RE: Searcy WWTF Inspection

AFIN: 73-00055 Permit No.: AR0021601

WATER DIVISION INSPECTION REPORT									
	ADLU	AFIN	l: 73-00055 PI	ERMIT #: AR0021 6	601			DATE: 8/24/2017		
_	RKANSAS	COU	INTY: 73 White		PDS #	: 0994	50	MEDIA: WN		
Dep	R K A N S A S artment of Environmental Quality	GPS	LAT: 35.26828	8 LONG: -91.7161	10 L0	CATI	ON: G	eneral Area		
	FACILITY INFORMAT	TION		INS	PECT	ION IN	IFORM	MATION		
	arcy WWTF			FACILITY TYPE: 1 - Municipal	9707	OR ID#: 2 S - S	tate			
	rth Bypass Rd.	FACILITY EVALUATION RATING: 1 - Unsatisfactor			Comp	on TYPE: Diance Evaluation				
Sea	arcy			(-)	RY TIME:	EXIT TI		PERMIT EFFECTIVE DATE: 10/1/2013		
	RESPONSIBLE OFFIC	CIAL						PERMIT EXPIRATION DATE:		
Dai	niel Dawson / Manager				21141.	- DEL /	TED	9/30/2018		
City	y of Searcy			FAYETTEVILLE S						
MAILI	NG ADDRESS:			FAYETTEVILLE S				IPANTS		
). Box 1319 State, zip:			NAME/TITLE/PHONE/FAX/EMAIL/	ETC.:					
	arcy AR 72143			Keith Waters/Wa						
	E & EXT: / FAX: -268-2481 /			Millie Remer/War Daniel Dawson/M

DMR Calculation Check

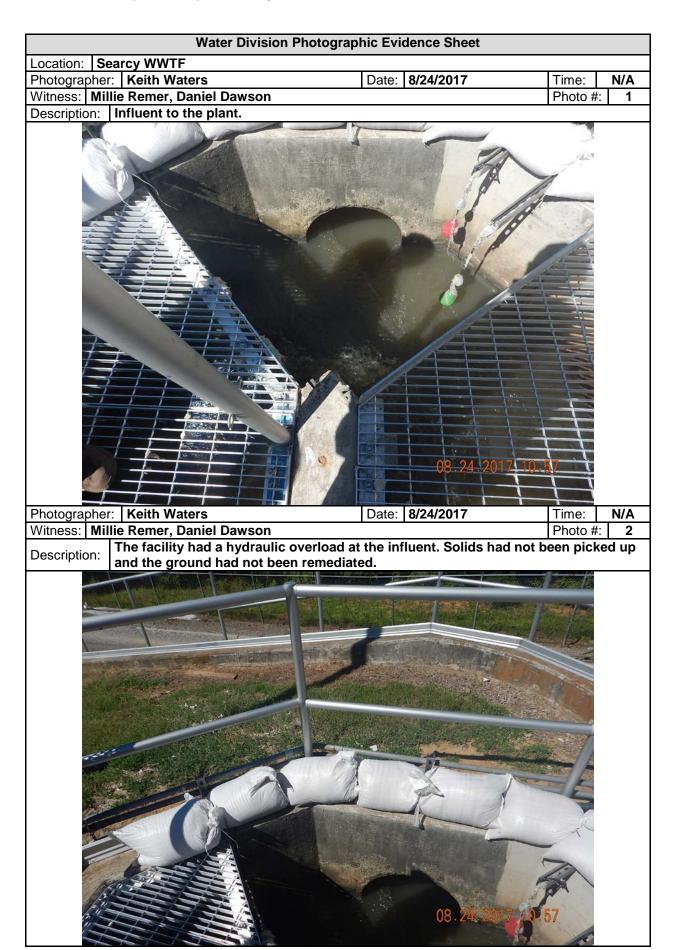
Loading rates for TSS do not match calculations done at the time of the inspection; all other loading rates matched the inspection calculations. The calculated value was still under the permit limitations.

The calculated loading rate in million colonies/day for FCB does not match what was reported on the DMR.

- 3. As for the "incorrect" loading rates being calculated on the May and July DMRs, it was found that the rates were, in fact, calculated correctly and this was verified by you with Mr. Tim Cleveland, hence no further response is necessary on this matter.
